Nibley Planning Commission

June 4, 2026

Maple View Hawk Preliminary Plat

Oak Haven Preliminary Plat

Oak Haven Preliminary Plat

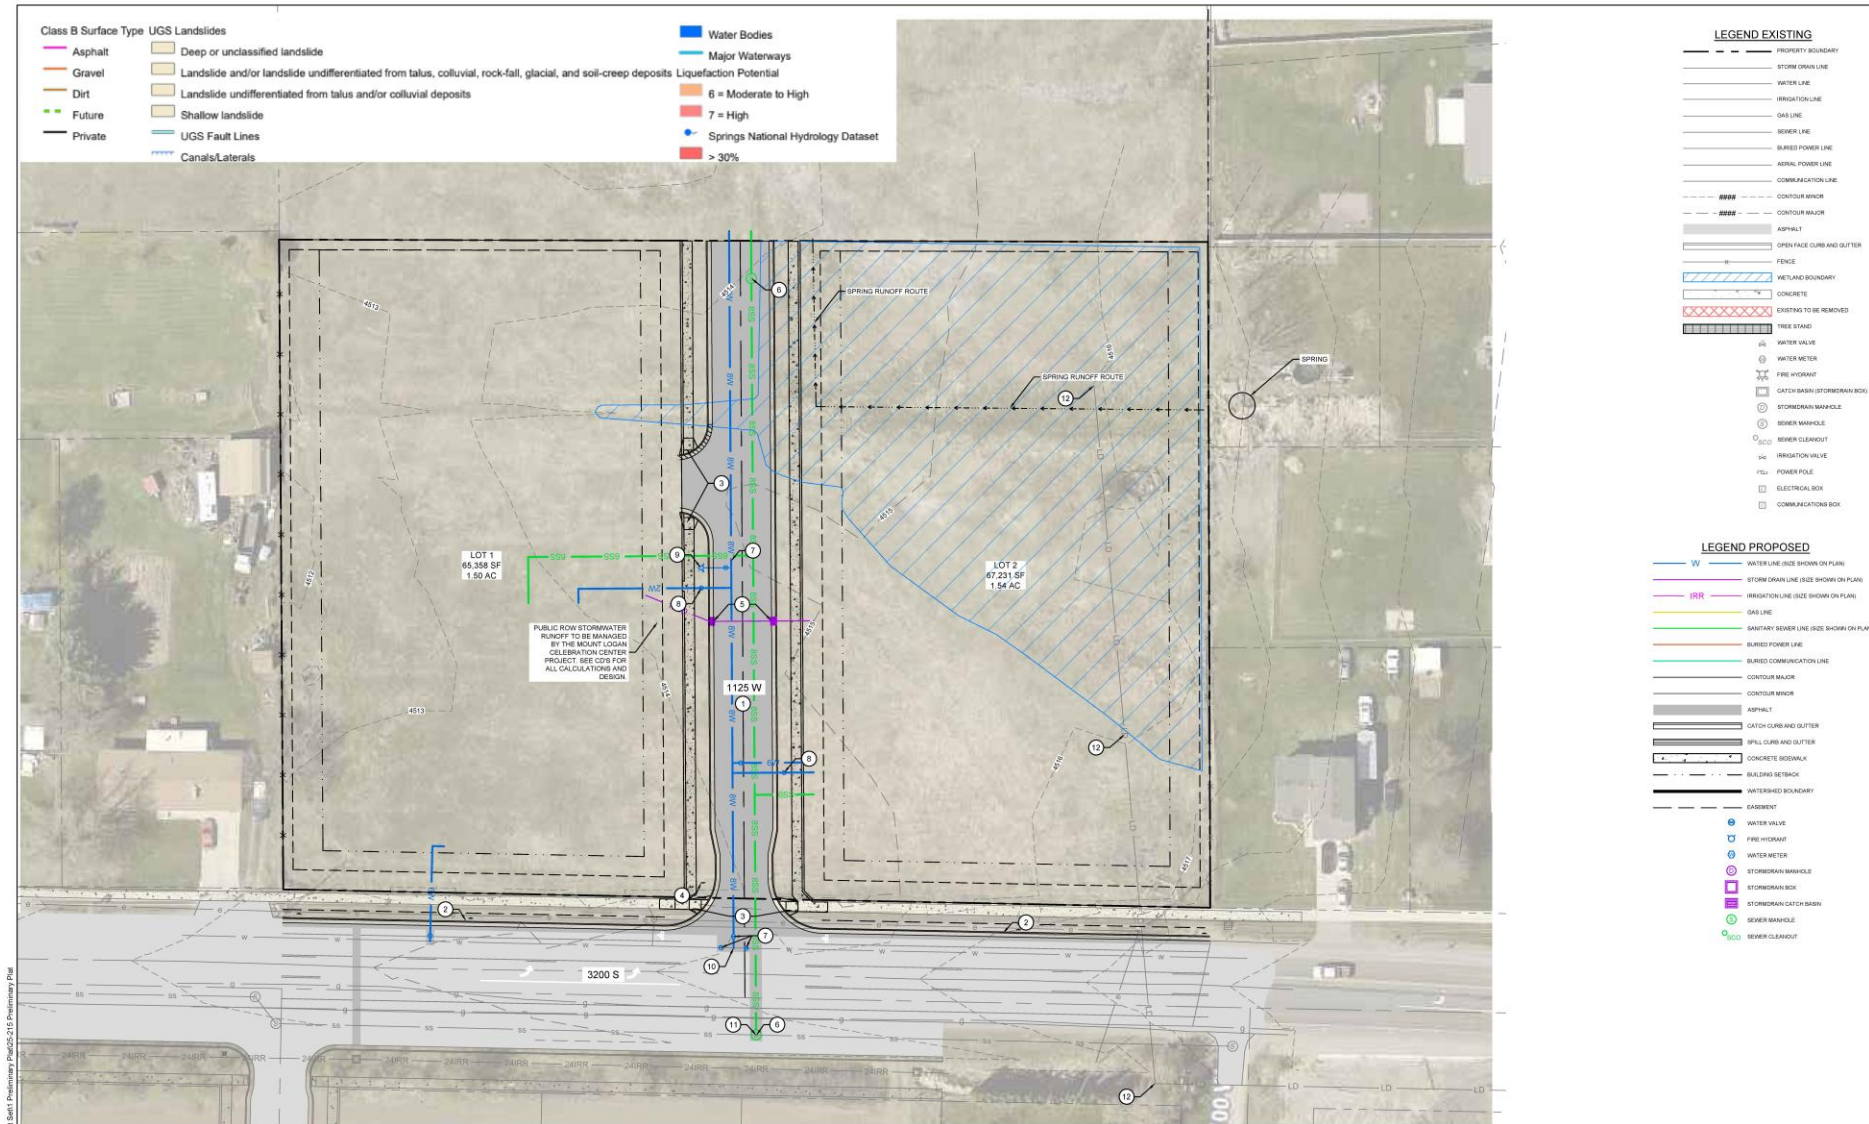
1. The Preliminary Plat adheres to zoning and space requirements.
2. Proposed relocated canals require appropriate irrigation easements per NCC 19.24.230.
3. Proposed public improvements are subject to further review in conjunction with Final Plat application.

1. Street, stormwater, sewer and water design subject to final approval of City Engineer to ensure adherence to Engineering Design Standards and master plans.
2. Adequate irrigation easements to be dedicated, including on adjacent properties where applicable, to accommodate relocated canal.
3. Street trees to be modified in accordance with Tree Policy Plan and per approval of City Arborist.
4. Irrigation system for sidewalk connector at the end of cul-de-sac to be modified subject to approval of City Engineer and Parks Supervisor.
5. A Stormwater Agreement will be needed at final plat and will be recorded on the property.
6. At Final Plat application, water and sewer models will need to be run and updated with cost born by the developer.

Mount Logan Celebration Center Preliminary Plat

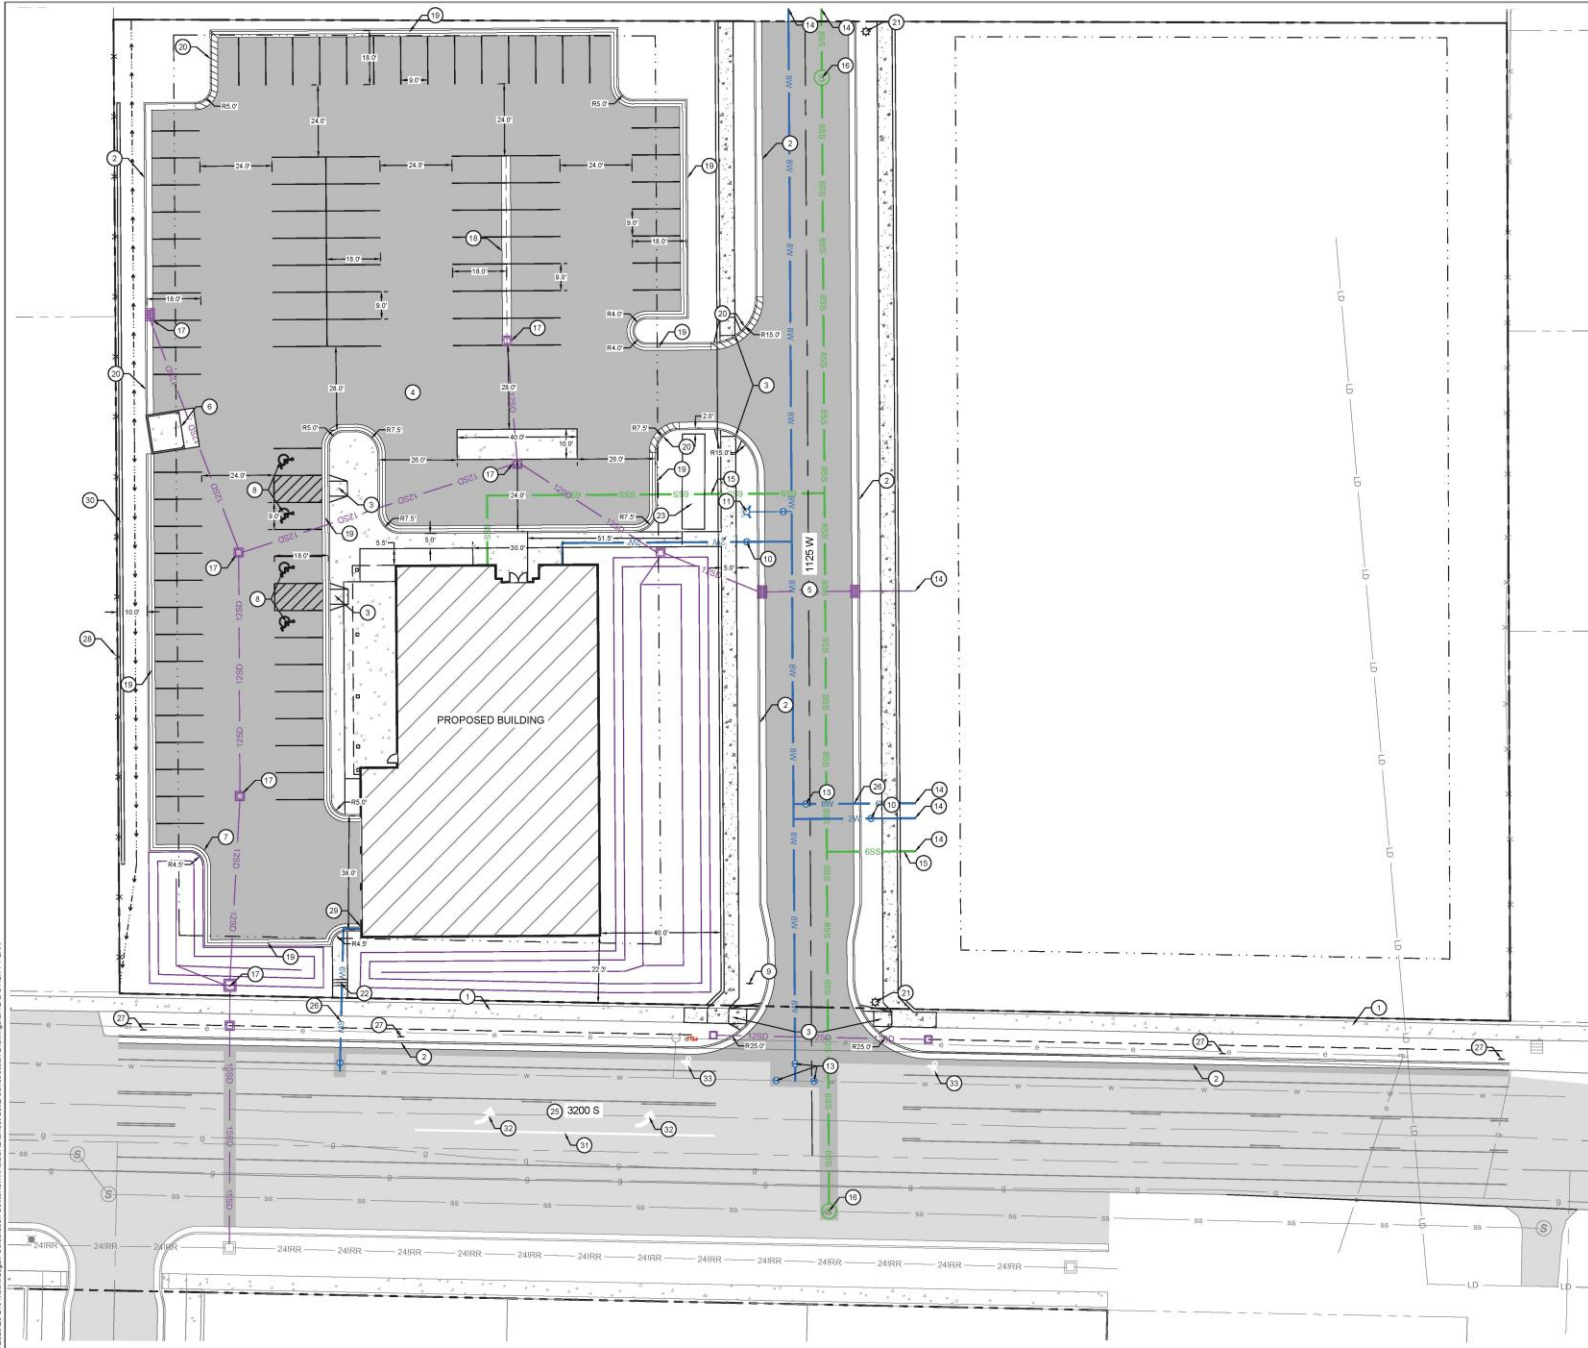
1. The Preliminary Plat adheres to zoning and space requirements.
2. Proposed public improvements are subject to further review in conjunction with Final Plat application.

1. Street, stormwater, sewer and water design subject to final approval of City Engineer to ensure adherence to Engineering Design Standards and master plans.
2. Final approval letter from Irrigation Company required prior to construction.
3. Provide an engineer's estimate for the cost of public infrastructure and public and private utilities such as communications, stormwater, etc.
4. Provide required dedication of water shares or rights prior to recordation of final plat or building permit.

ARCHITECTURAL ELEVATIONS
A201

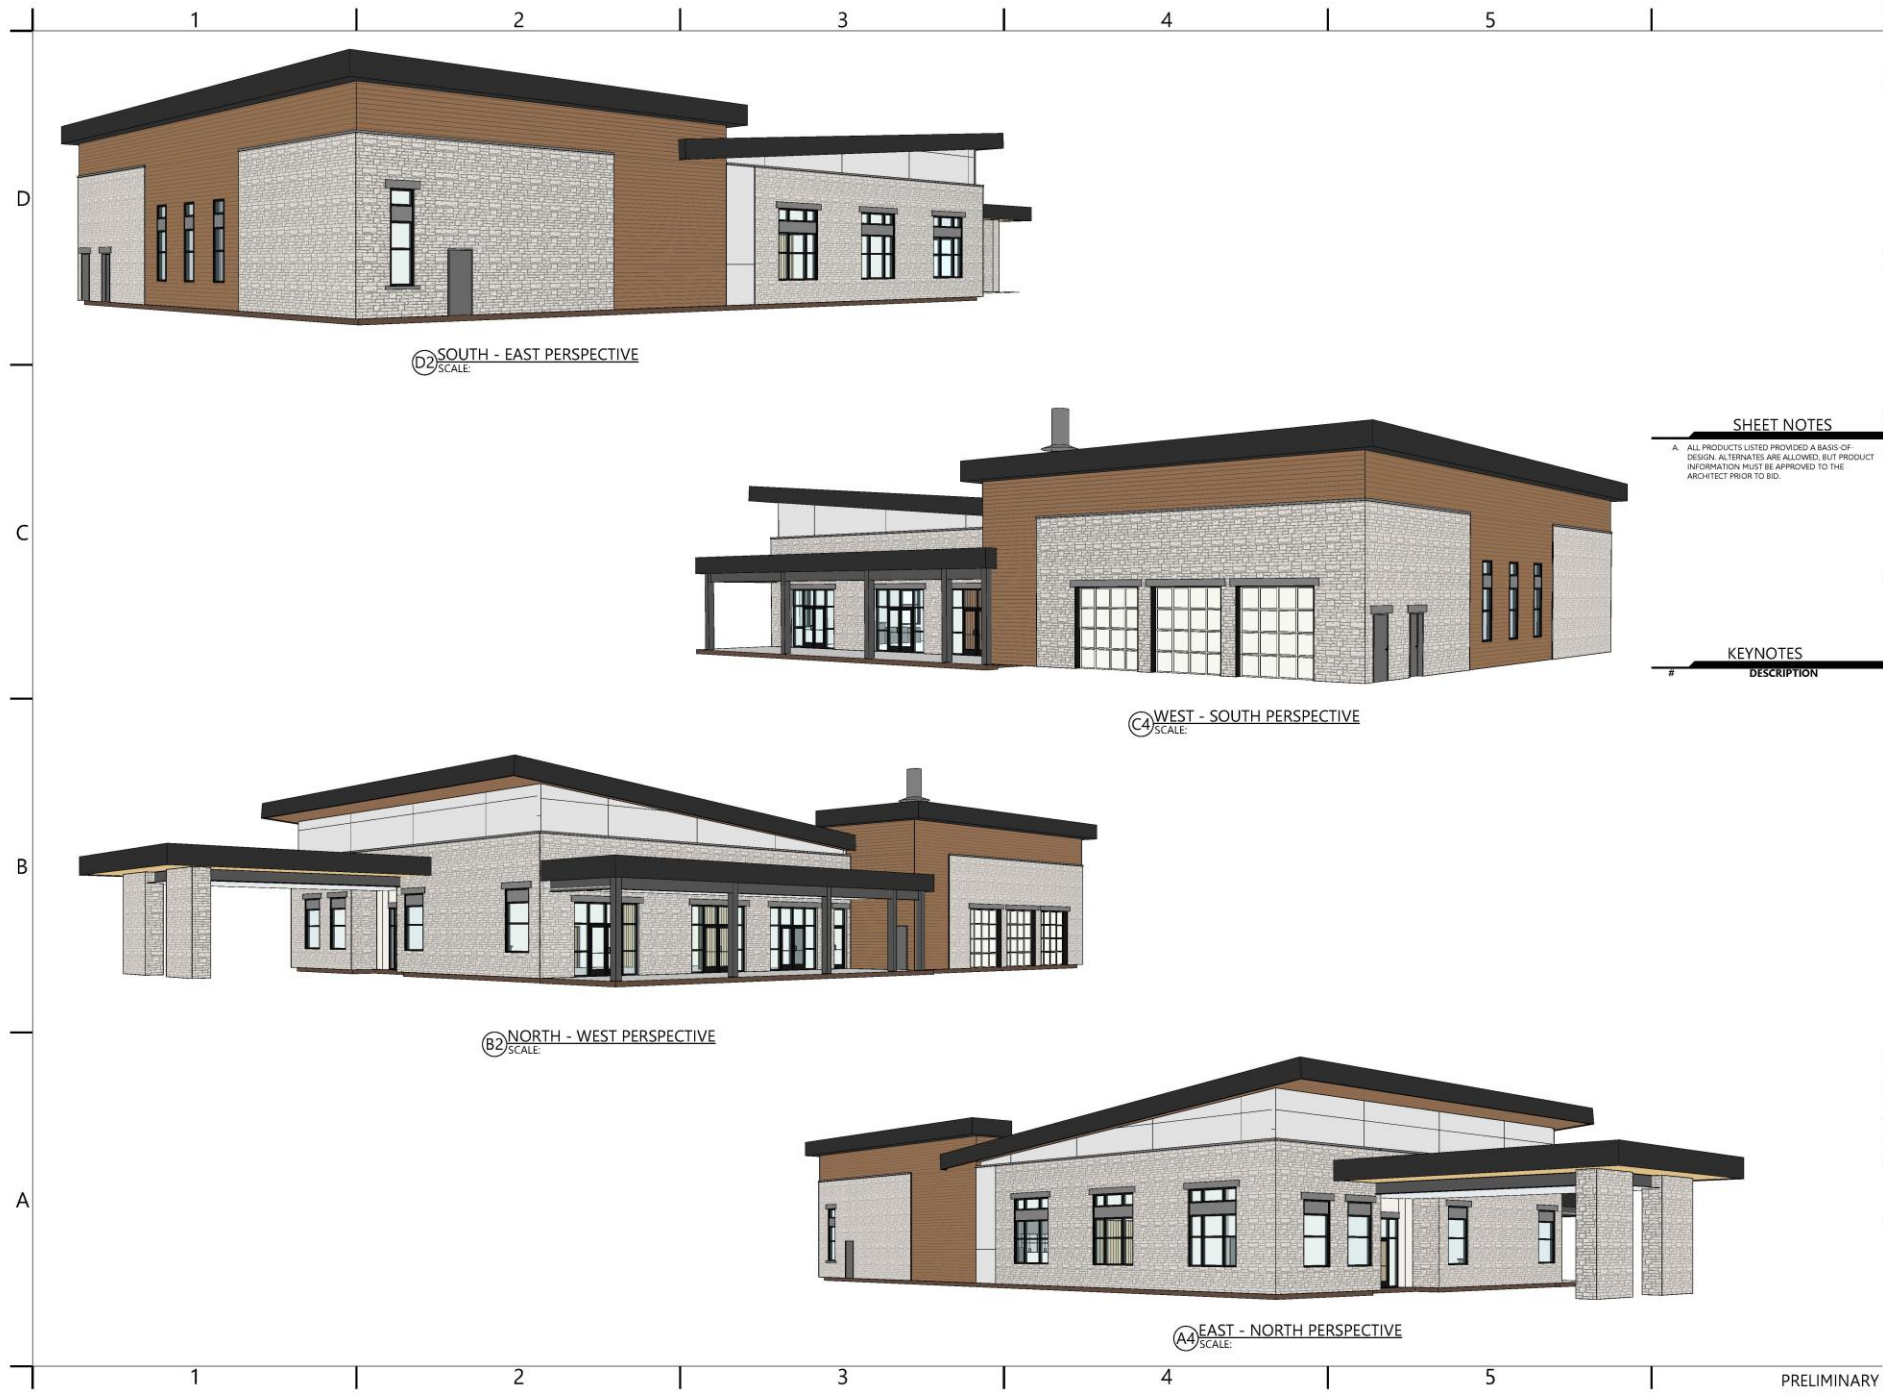
- Applicant proposes exception to allow 52% of façade facing 3200 S as Stone with 48% wood.
 - Design standards allow for “exception[s] in the case of innovative design, and variances are allowed at the discretion of the governing bodies. Innovative design that achieves improved energy efficiency is an example of where the governing body may consider specific exceptions to these standards.”

- Applicant has proposed 12% fenestration with the following justification:

1. The application is compliant with Nibley City Design Standards for Commercial and Institutional Uses with the exception of minimum fenestration on the primary building façade and required primary building materials, but has provided a justification for an exception to these standards.
2. More detail is needed to ensure compliance with NCDSCIU 3.6.3 and NCC 19.14.070(L) for dumpster enclosure.
3. The application is compliant with minimum parking standards of NCC 19.24.160.
4. The proposed utility plan complies with Nibley City Engineering Design Standards and Specifications.
5. The proposed use is a permitted use in the Neighborhood Commercial (C-N) Zone.

5. All exterior lighting will need to adhere to Nibley City Outdoor Lighting standards. This will be verified at time of building permit.
6. Need to provide elevations and/or rendering of enclosure to ensure design is compatible with primary structure with 3 opaque sides and one movable opaque side. Compliance with standard to be verified by City Planner.
